PUBLIC HEARING MEMORANDUM

SUBJECT: **Petition #29-21**, for SPECIAL PERMIT/SITE PLAN APPROVAL to allow four single-family attached dwellings in two buildings with the following dimensional waivers: reduced side setbacks, increase in the allowed lot coverage, to allow a driveway within ten feet of the side lot line and to allow retaining walls greater than 4 feet in height within a setback at 145 Warren Street, Ward 6, Newton Centre, on land known as Section 61 Block 39 Lot 10, containing approximately 23,399 sq. ft. of land in a district zoned MULTI RESIDENCE 1. Ref: Sec. 7.3.3, 7.4, 3.4.1, 3.2.4, 6.2.3.B.2, 5.4.2.B of Chapter 30 of the City of Newton Rev Zoning Ord, 2017.

145 Warren Street

ZONING REVIEW MEMORANDUM

Proposed Front Elevation

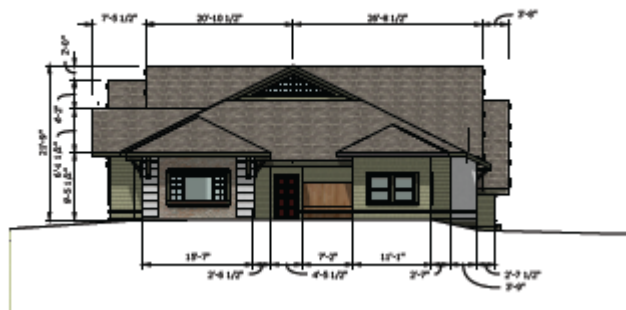
As the proposed single-family attached dwellings are considered one structure, the height of the structure is 30.05 feet. Unit 1 maintains the existing house and Unit 2 is connected at the rear of Unit 1 and where the property begins to slope downwards allowing for the basement to be partially exposed. Units 1 and 2 are connected to Units 3 and 4 by a one-story garage with a semi green roof, which serves as a courtyard between Units 2 and 3. Units 2 and 3 consist of 2.5 stories due to the grade leveling off and further exposing of the lower level. This leveling of the grade renders the basement of Units 3 and 4 as the first story. The structure will present as one story from the front elevation, and three stories as the site slopes downwards into the site towards the rear property line. From the western and eastern elevations, the structure presents as two separate structures breaking up the façade so as not to appear as one continuous wall.

The petitioner is proposing a total of four units that range from 2,566 square feet to 3,147 square feet. Unit 1 accounts for the existing house. The petitioner should confirm the gross square footage of each unit.

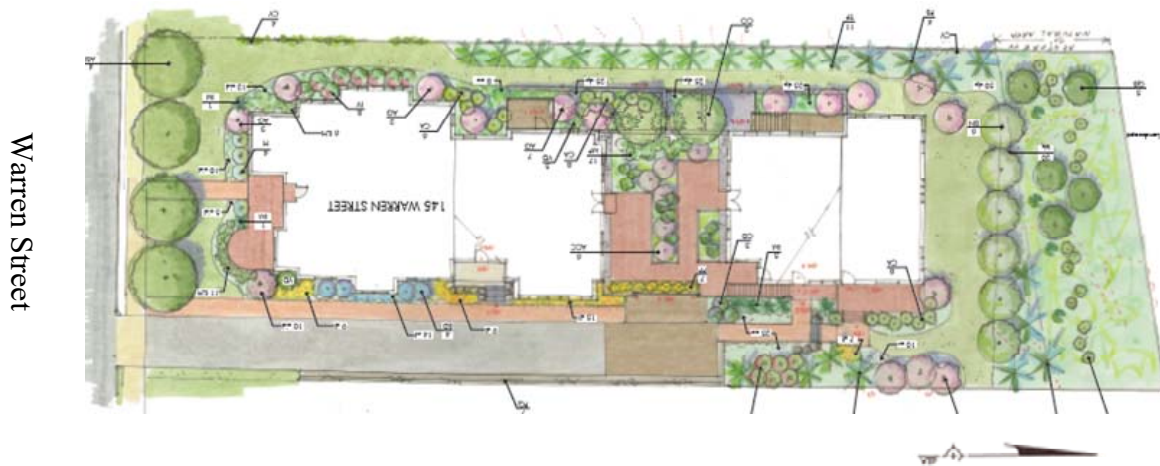
The petitioner is proposing to move the curb cut to the east along the frontage. The driveway will be extended to provide access to the shared lower-level parking facility and has a width of 13.7 feet with an adjacent walkway. The petitioner should confirm the width of the proposed curb cut as well as the proposed walkway. The driveway configuration requires relief for a driveway within ten feet of the side property line at the eastern boundary.

The petitioner requires additional relief under section §5.1.8 for the design of parking facilities over five stalls. As the proposed parking consists of eight stalls, the facility falls under the standards of §5.1.8. The section requires that entrance and exit driveways be 20 feet wide for two-way use. The petitioner is proposing an entrance and exit driveway with a width of 13.7 feet and additional space for a walkway at the same grade of the driveway. Once the requirements of §5.1.8 are fully reviewed, a new zoning review memorandum will be issued.

The lower-level parking garage has designated space for two cars per unit. The petitioner provided a garage plan with turning templates currently under review by the Engineering Division.
